SECTION 96 SUBMISSION

DEE WHY RSL CLUB - 932 PITTWATER ROAD  
STAGE 5 CLUB EXTENSION

DRAWING TITLE:  
SHADOW DIAGRAM - 21 JUNE

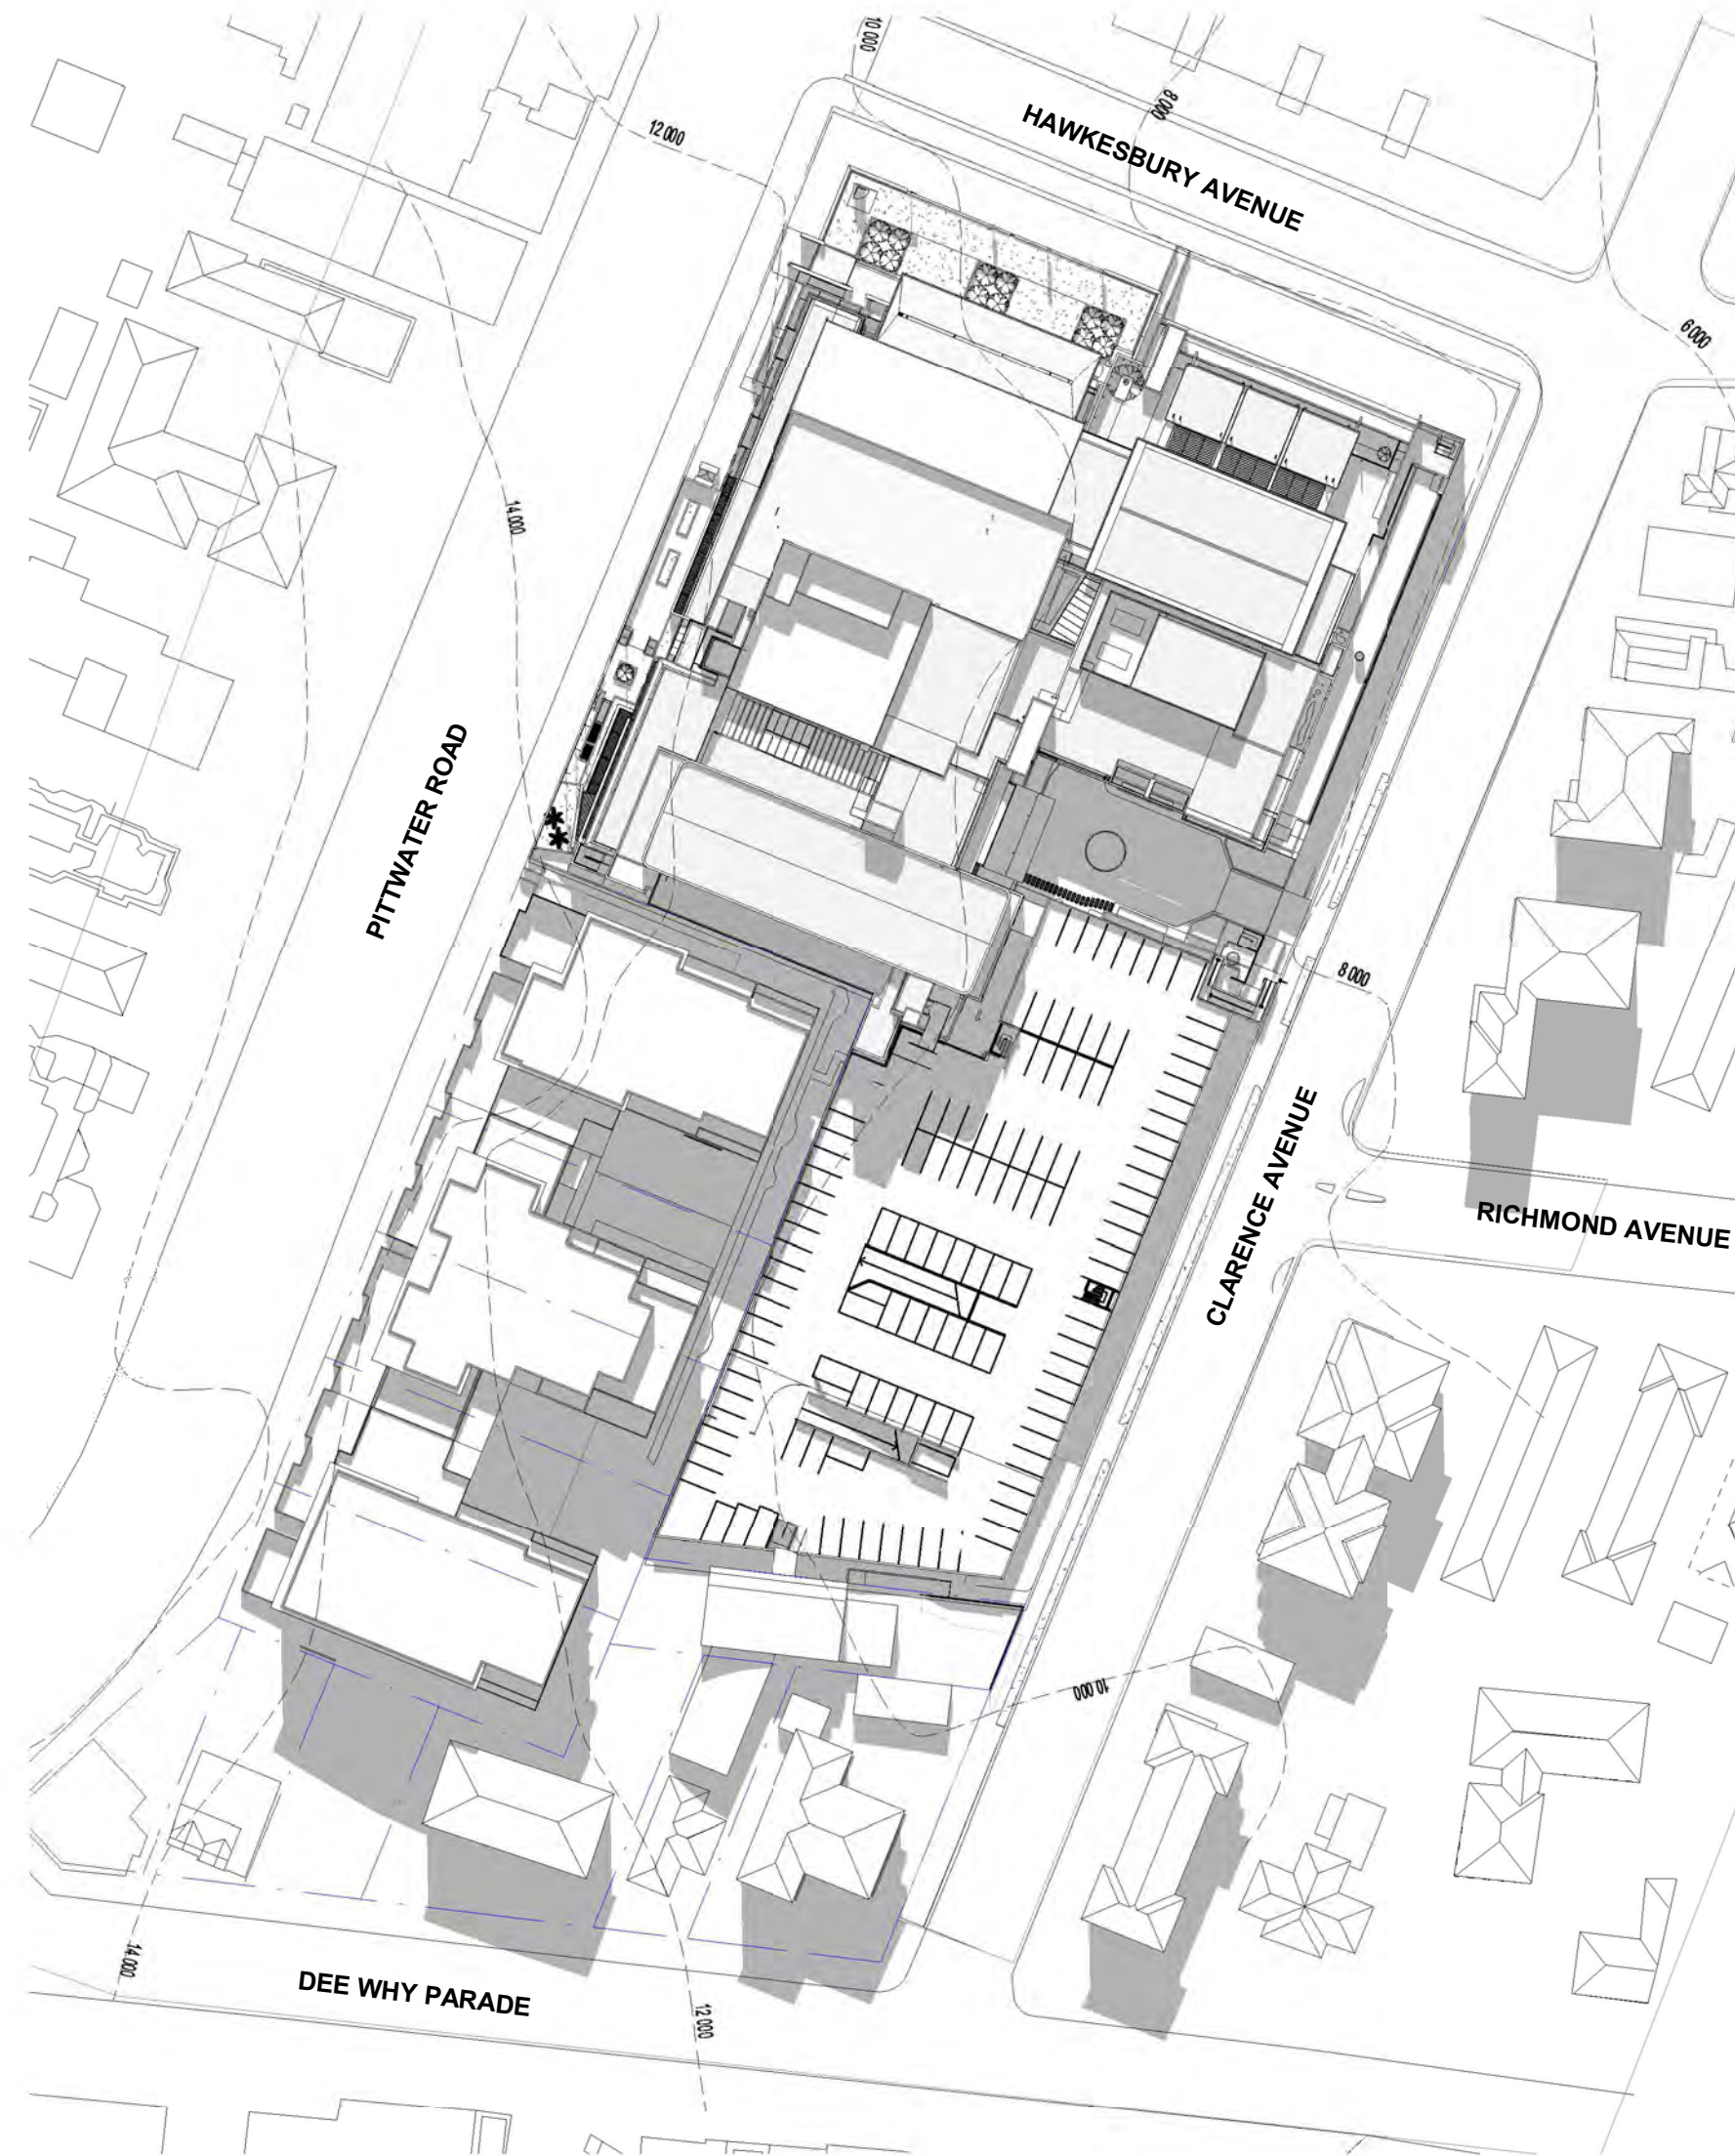
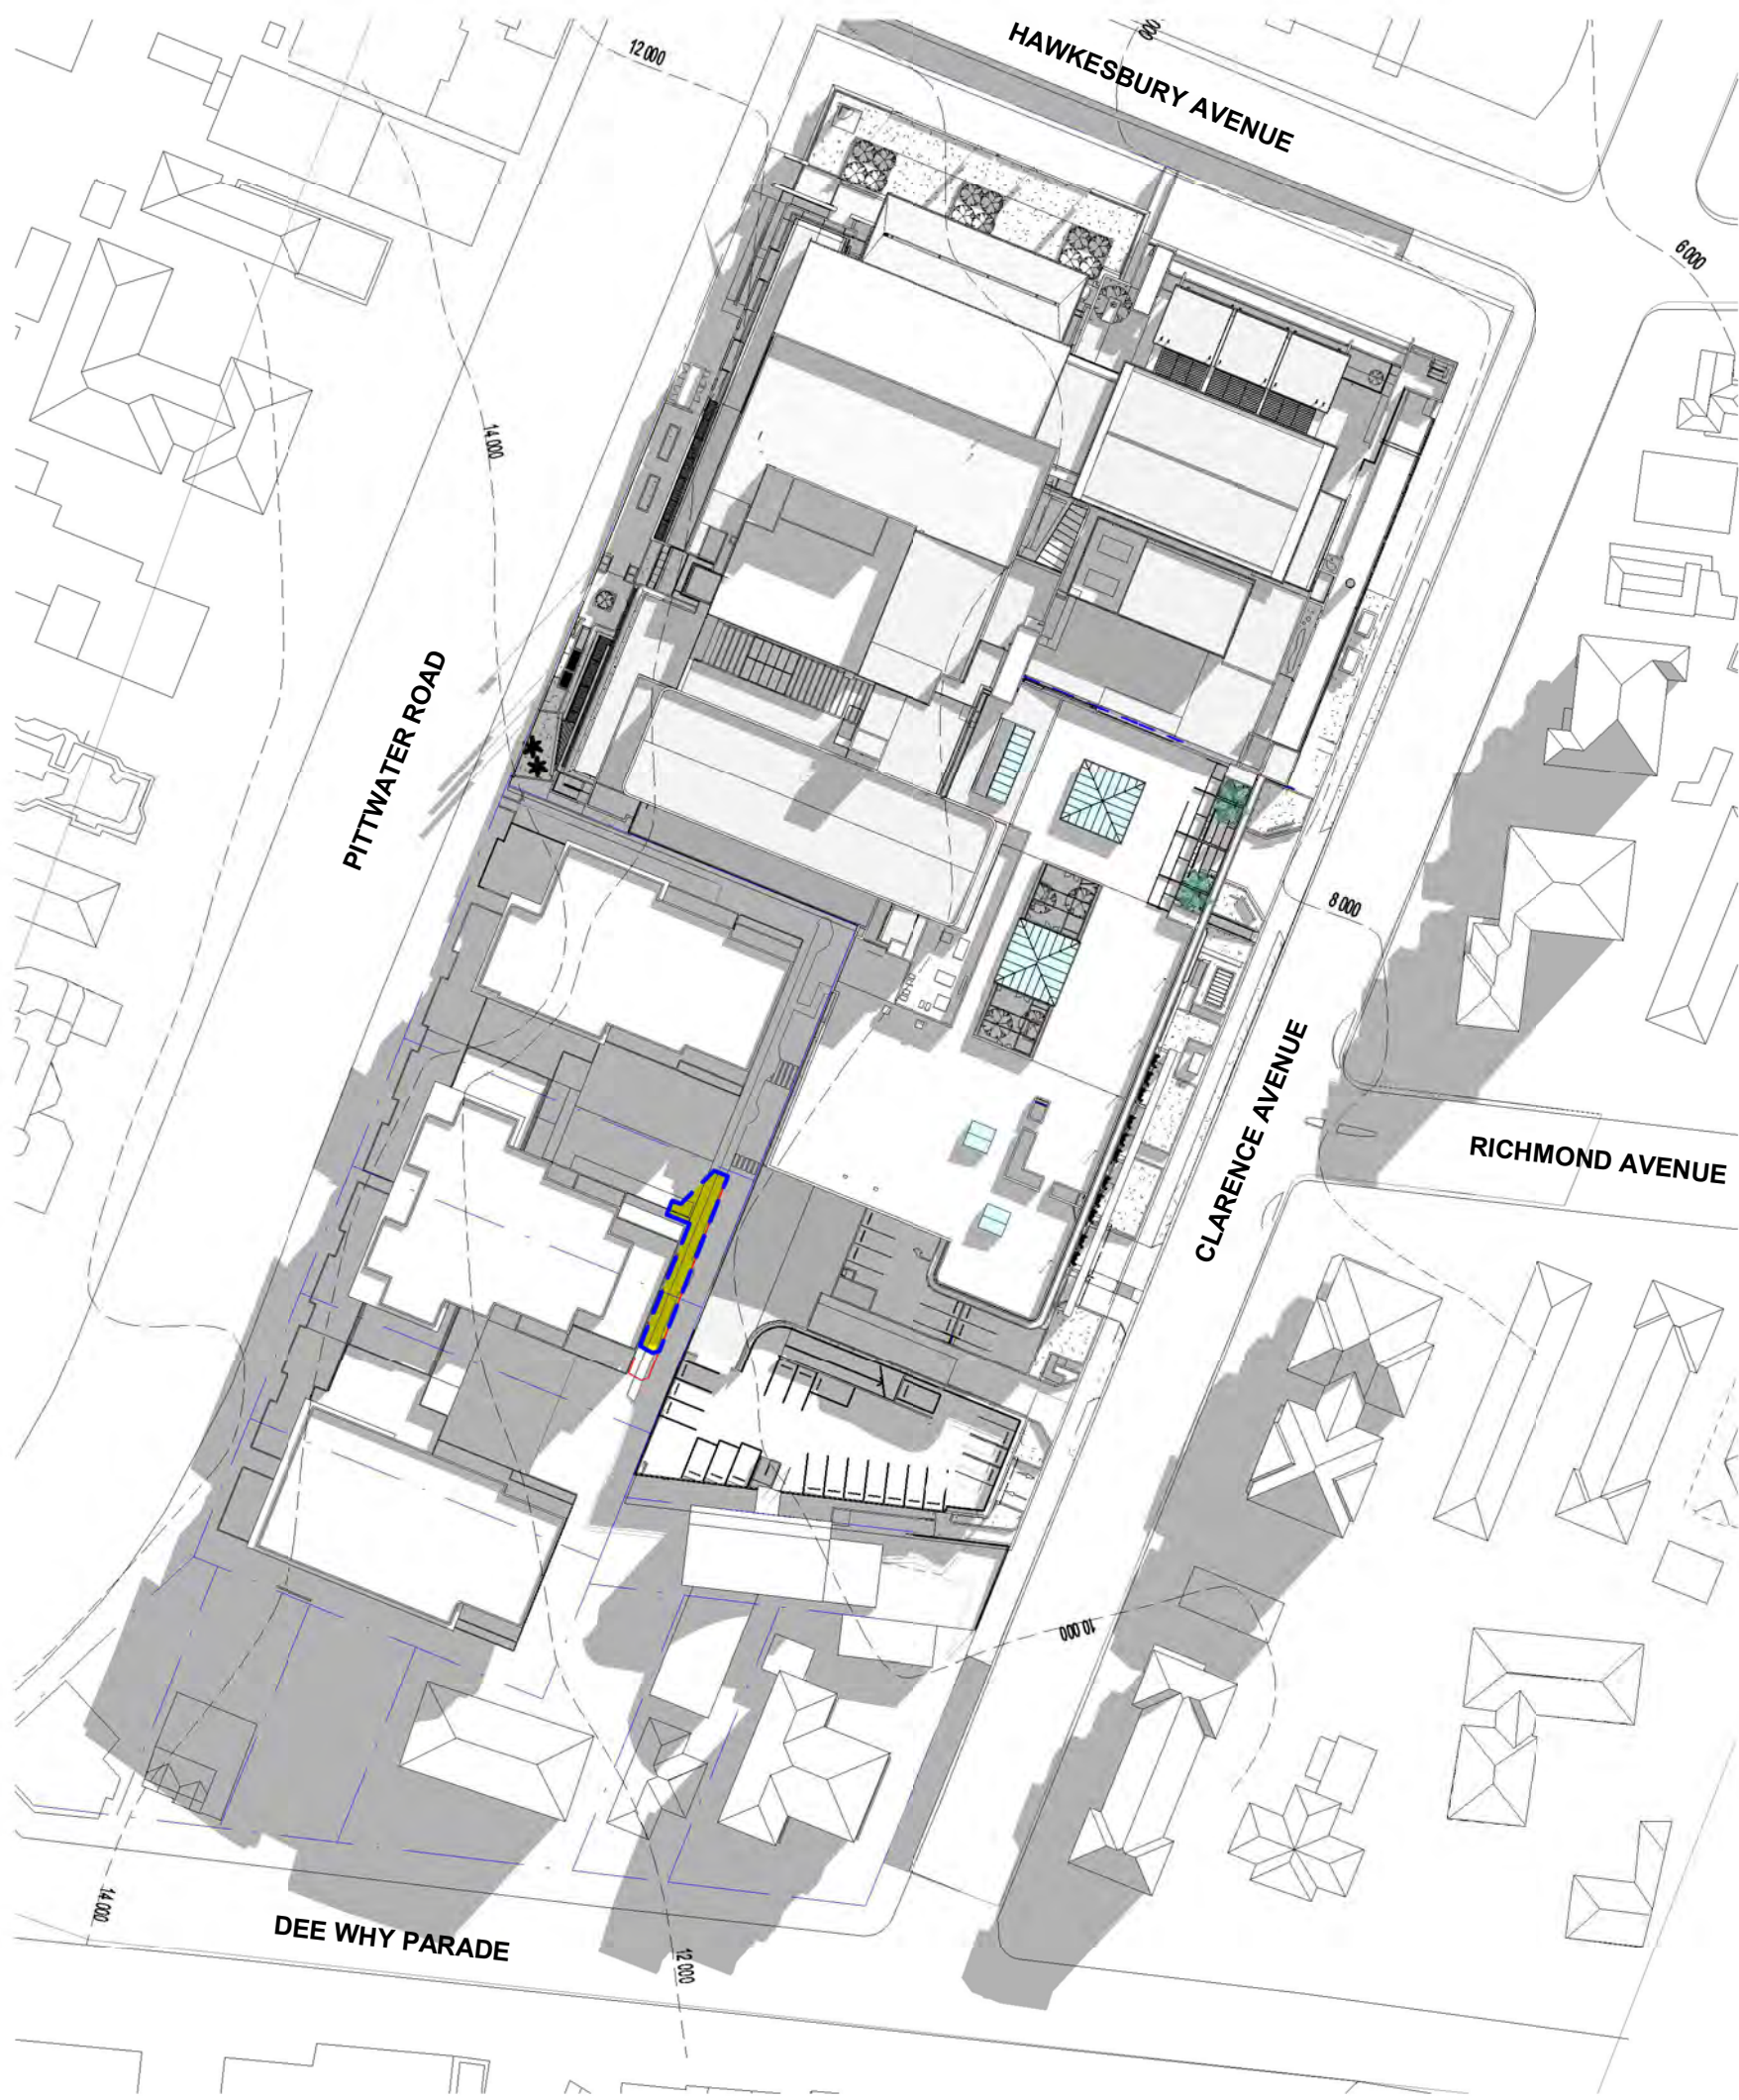
- SHADOW CAST BASED ON SECTION 96 MODIFICATIONS, REDUCED IMPACT
- SHADOW CAST ONTO SURROUNDING BY PROPOSED DEVELOPMENT AS PER ORIGINAL DA 2017/0244
